EEG-82

EVALUATION OF PROPOSED PANEL CLOSURE MODIFICATIONS AT WIPP

December 2001

Review of Panel Closure Bulkhead Enhancements, Waste Isolation Pilot Plant
John F. Abel

Figure 2.   Explosion-isolation masonry wall bulkhead

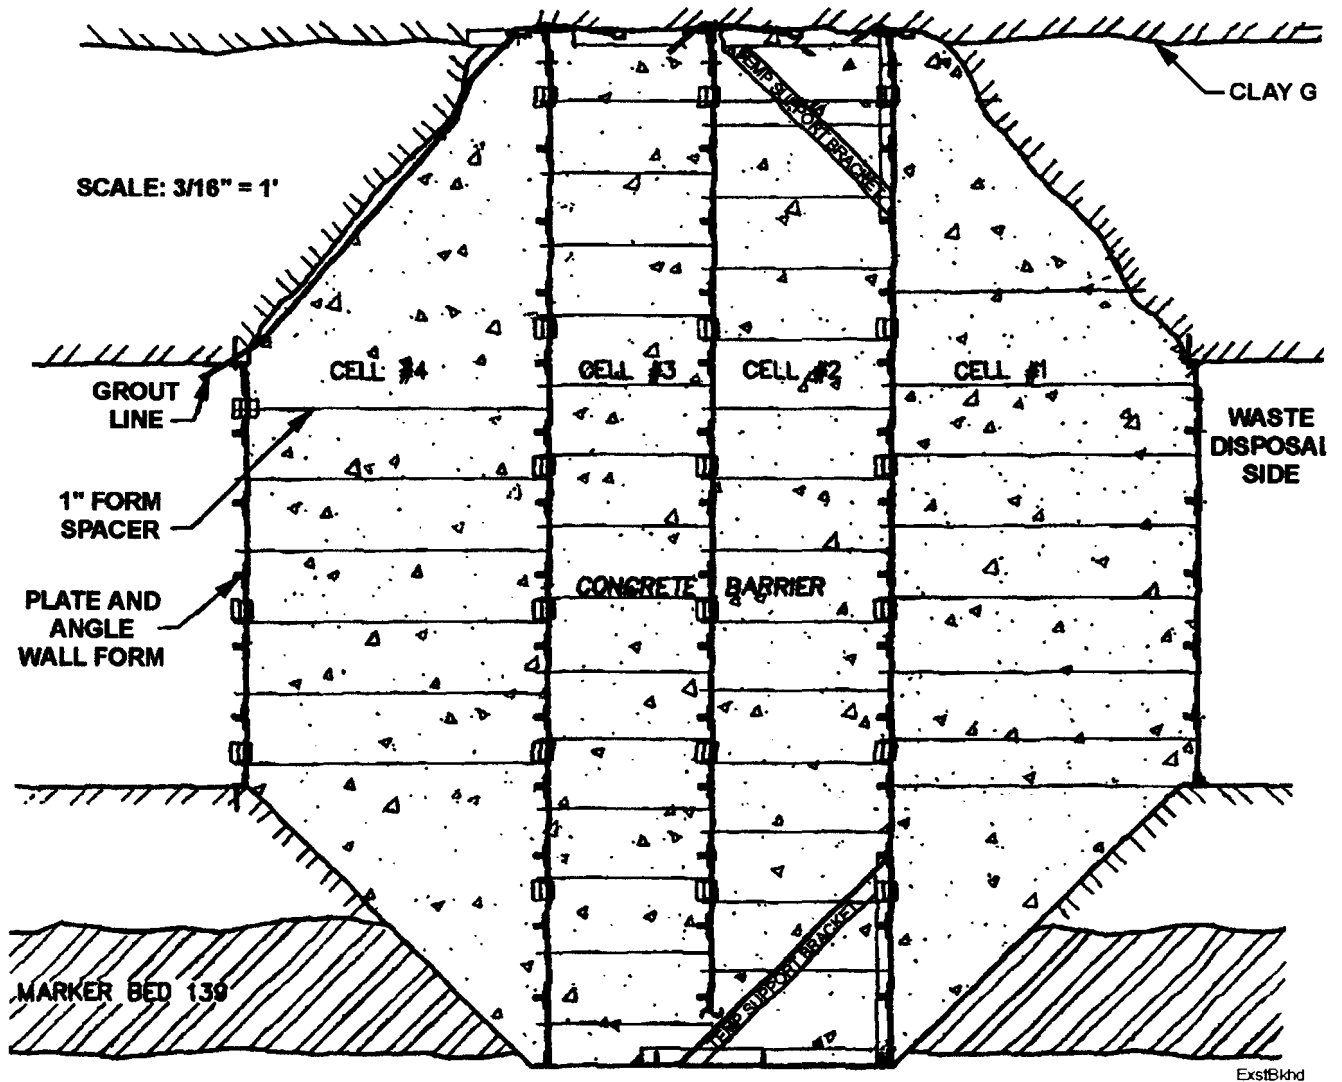
The 12-ft thick explosion-isolation masonry walls for the
Intake Drift and the Exhaust Drift (Figure 2) are planned to be
built with solid concrete blocks (3,500 psi) mortared with
cement and hitched 6-in into the roof, ribs and floor. The
explosion-isolation masonry wall is apparently designed to
resist the 480 psi methane explosion pressure during the six
months to one year of panel bulkhead construction.

The ability of the planned explosion-isolation masonry
walls to resist the 480 psi methane explosion pressure was
conservatively checked using the water impoundment bulkhead
design method (Abel, 1998). Table 1 presents the results of
this analysis. The calculations for the Intake Drift are
presented in Appendix C and for the Exhaust Drift in Appendix D.
The results of this analysis predicts that the planned 12-ft
thick explosion-isolation masonry walls would not be capable of
resisting the 480 psi design methane explosion pressure. The
predicted failure of the explosion-isolation wall is indicated
on Figure 12. In the Intake Drift, the thickness of an
explosion-isolation masonry bulkhead would have to be
approximately 20-ft to contain the 480 psi methane explosion
pressure and in the Exhaust Drift approximately 15-ft.

The planned 12-ft thick explosion-isolation masonry walls should not be built. The methane concentration will take more than 17 years to rise to the 5% lower explosive limit after stopping panel ventilation. If built, the planned 12-ft thick explosion-isolation masonry walls would probably be incapable of resisting the design 480 psi methane explosion pressure.

Figure 3.   Methane concentration in waste panel over time

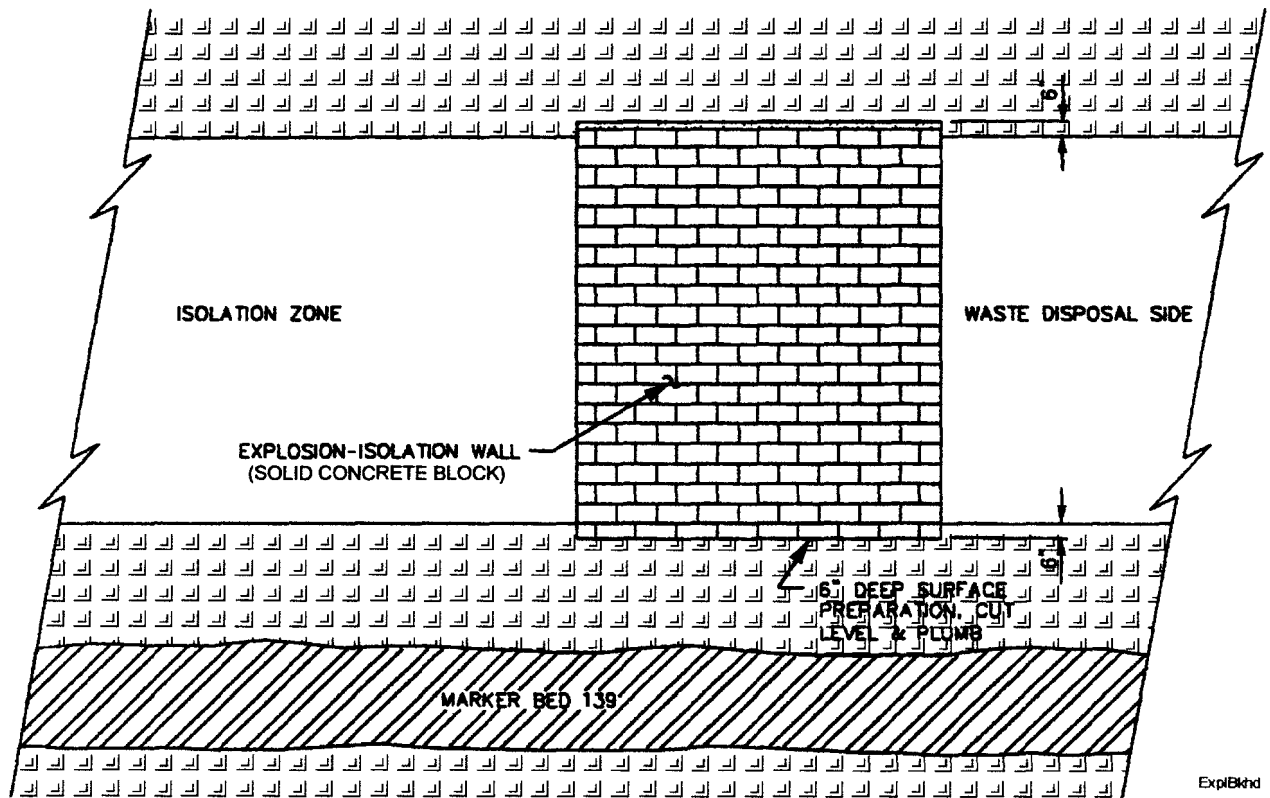
Figure 3 presents the predicted 17+ year methane
concentration time interval between cessation of panel
ventilation and the methane concentration reaching the minimum
5% lower explosive limit. The predicted methane concentration
should not exceed approximately 0.25% during a one-year panel
closure bulkhead construction period. Therefore, a methane
explosion should not be possible, and an explosion-isolation
masonry wall not necessary.

Figure 4.   Water impoundment bulkhead types

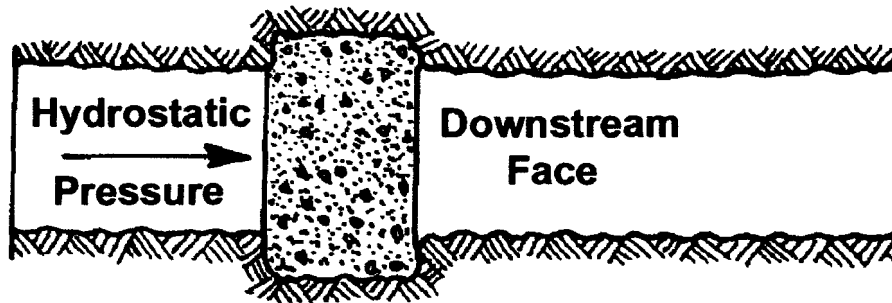
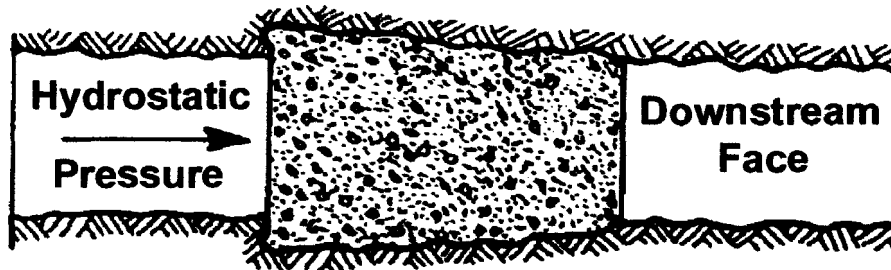
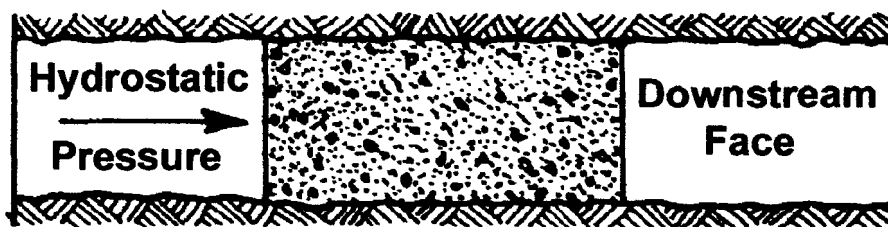
Tapered bulkhead water containment bulkheads are normally
constructed when the rock shear strength is lower than the
concrete design shear strength. Figure 4 shows a typical
tapered water containment bulkhead, designed to resist
hydrostatic pressure from one side. Successful tapered
bulkheads have been constructed at the Summitville Mine, the
Jackpot Mine declines and at IMC's K2 Mine. Tapering a bulkhead
increases the length of the worst-case potential shear surface
in the lower strength rock adjacent to the rock/concrete
interface and tightens the concrete bulkhead against the rock
when hydrostatic pressure is applied. In most water impoundment
cases, when the rock strength exceeds the concrete strength,
parallel plugs have proven to be effective. Loofbourow in the
Society of Mining Engineers (SME) Mining Engineering Handbook
(1973, Sec 26.7.4) states "no indication of structural failure
resulting from thrust was noted" in the case of ten bulkheads

subjected by hydraulic pressures in excess of 1000 psi and which
relied solely on normal rock surface irregularities, referred to
as a "parallel plug" on Figure 4. Garrett and Campbell-Pitt
(1961) reported the successful results from 26 mine bulkheads,

Figure 10. Optional designs for panel closure systems

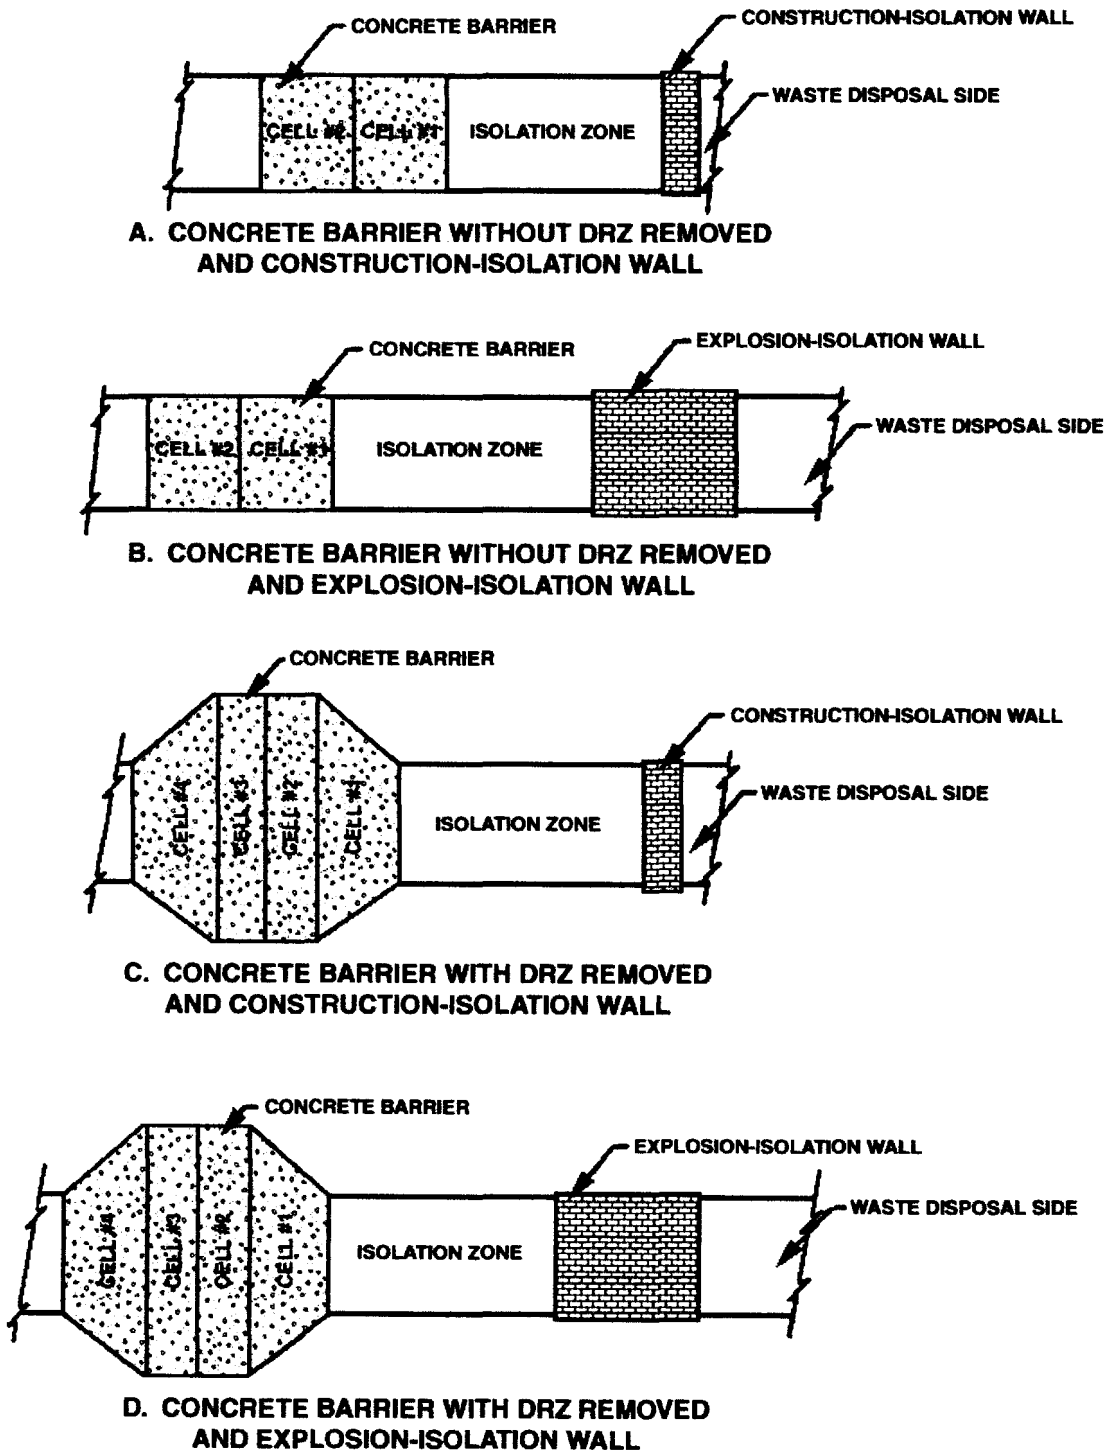
The panel closure bulkhead design (Figure 1 and Figure 10) is not a monolith because it is planned to be built using four

Parallel panel closure bulkheads would probably be
successful in resisting the potential applied pressures, Options
A and B on Figure 10. However, the progressive deterioration of
the adjacent rock salt and anhydrite and clay layer bed
separations suggests that the two-way tapered bulkhead will
assure the long term functioning of airtight panel closure
bulkheads.

Figure 13. Example of effect of temperature on setting time of concrete

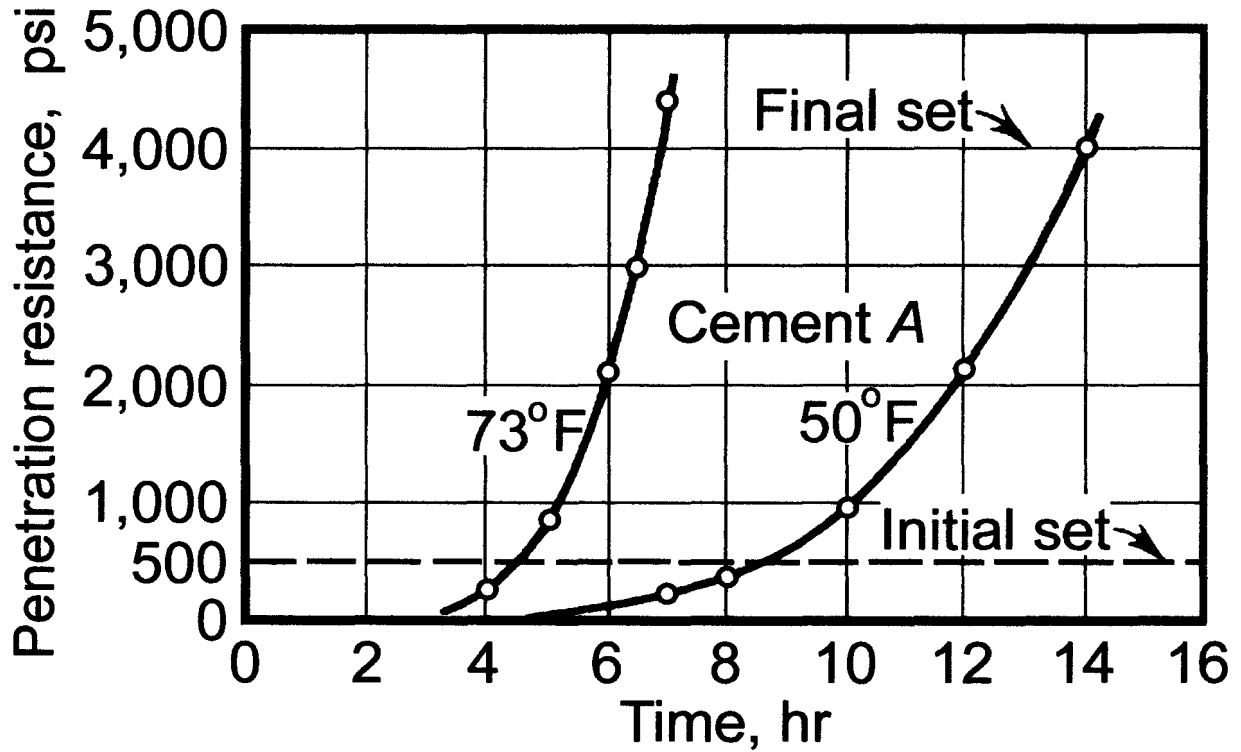
cells. The steel forms will restrain the concrete pumped into each cell until the initial set, which will take approximately 4 hours (Figure 13). Most water retaining bulkheads (Figure 4) are designed and constructed as monolithic, i.e. continuous, pours without cold joints or interior form walls. Figure 14 provides a longitudinal cross section of the reinforced concrete American Tunnel Bulkhead #1, designed to resist a 1550-ft head (670 psi) and supporting 1010-ft (438 psi). Note the waterstops on the bypass pipe and the grout holes drilled through the concrete to low-pressure grout the roof and rib contact between the 11,000 psi compressive strength latite porphyry and the 3,000 psi concrete.
